# B&W FUEL COMPANY

May 10, 1993

REFERENCE: Certificate of Compliance for Model No. 51032-2,  
Docket 71-9252

MODEL 51032-2 SHIPPING CONTAINER  
SIDE DROP ANALYSIS

# Figure 1 - Strongback Channel

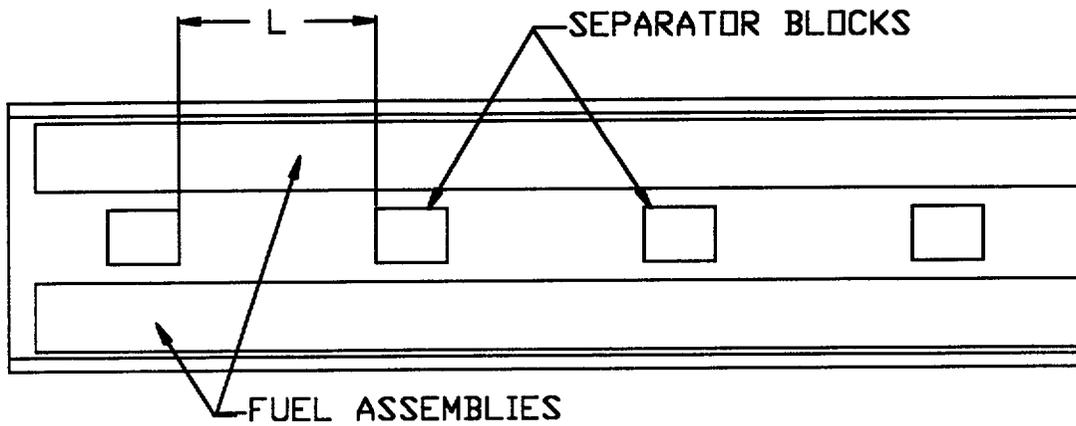
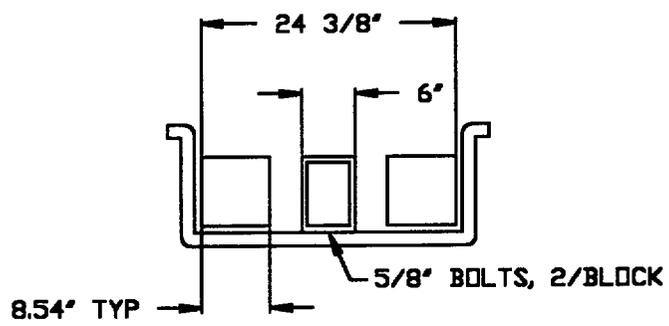
2. The side drop analysis shown in Appendix 1A should be revised to consider the following:
- a. The clear distance between separator blocks required to maintain a six inch minimum separation between fuel assemblies appears to be calculated non-conservatively. The factor L/29 should not be used to reduce the

rotational angle.

- 2a. The clear distance required to maintain a six inch minimum separation between fuel assemblies within the 51032-2 container strongback has been recalculated and is documented in Appendix 1A to this letter. The analysis has also been included as Appendix D to the SAR.
- 2b. The impact force of 82,680 lbs. was conservatively estimated for purposes of examining the strength of the separator bolts, only. A more realistic separator loading analysis was performed and is shown in section 5.3 of Appendix 1A. This is also included in Appendix D to the SAR.

Fuel assembly-to-separator block spacing (See Figure 1), prior to drop, assuming the fuel assembly outer envelope is 8.54 in. for MK-B, can be calculated as follows,

$$(24.375 - (2)(8.54) - 6)/2 = 0.648 \text{ in.}$$

Therefore,  $\delta_{\max} \approx 0.648 \text{ in.}$ , to maintain a 6 inch minimum fuel assembly spacing.

$$\therefore L = (0.648/0.00496)^{1/2} \approx \underline{11.4 \text{ in.}}$$

# Figure 2 - Separator Block ANSYS Model

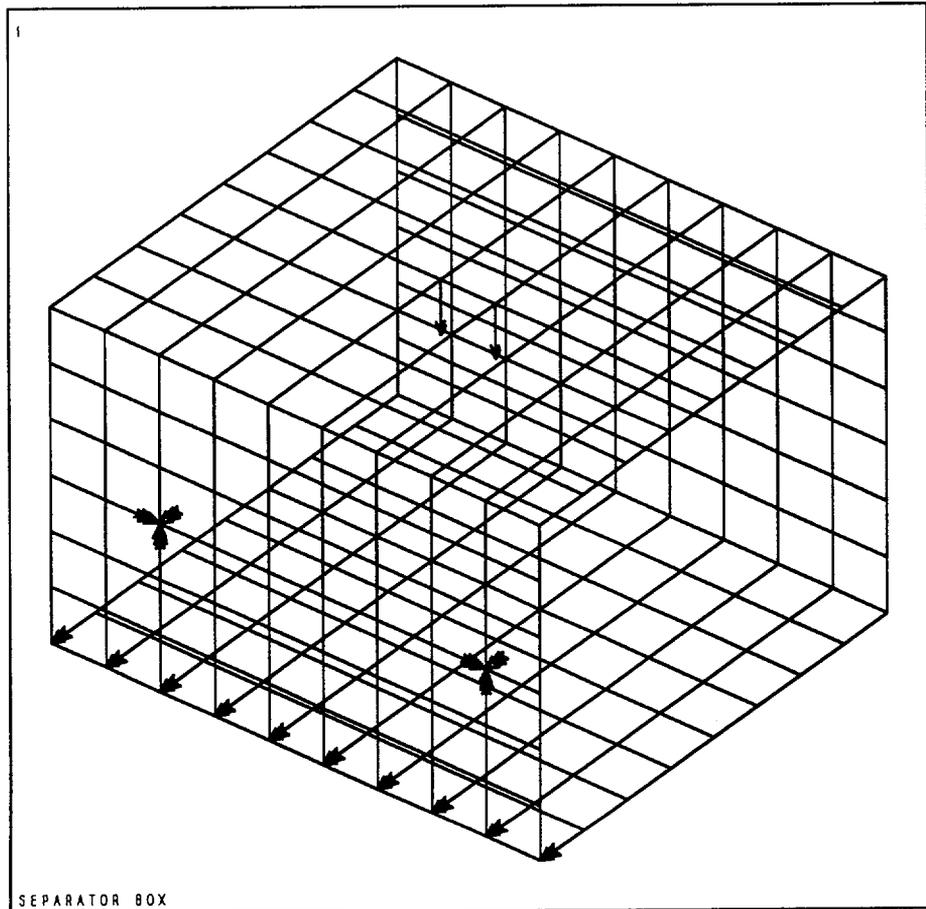
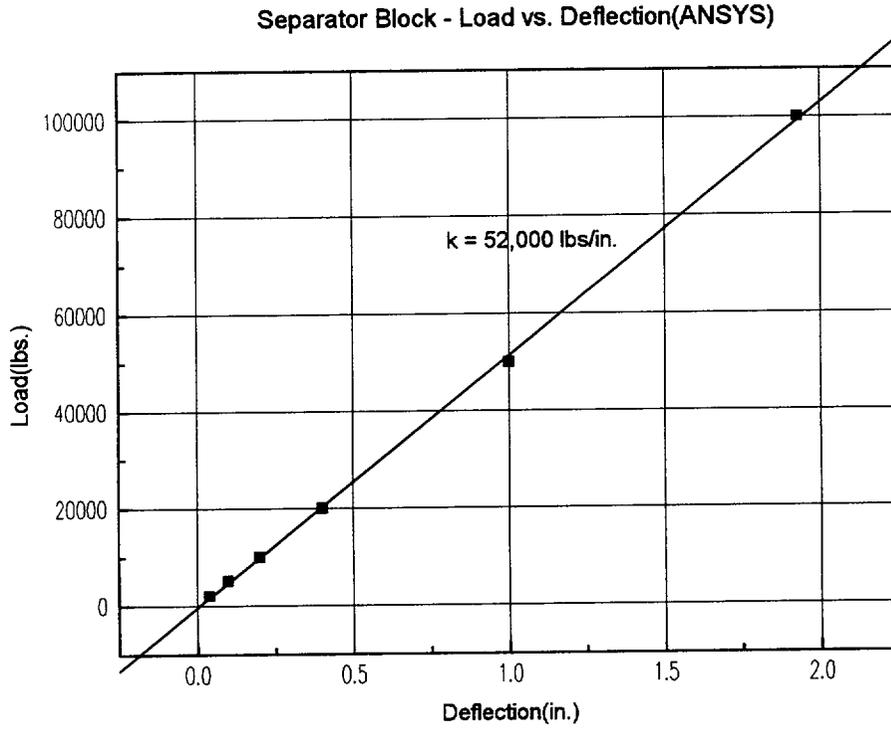
- b. The impact force (82,680 lbs) is too large for the 1/4-inch thick strongback or the 3/8" thick separator block to bear.

### 5.3 Realistic Separator Block Loading

Assuming, conservatively, that the "dynamic" yield strength of the 1/4 inch strongback equals the "static" yield strength, or 36,000 psi., and that the one inch separator block bolts are used, the maximum bearing load that the strongback can take is calculated as follows,

$$P_{\text{max}} = (2) (0.25 \text{ in.}) (1 \text{ in.}) (36,000 \text{ psi.}) (9 \text{ separator} \\ \text{Blocks}) \\ = 162,000 \text{ lbs.}$$

$$\text{M.S.} = \frac{98 - 74}{74} \times 100\% = 32\%$$
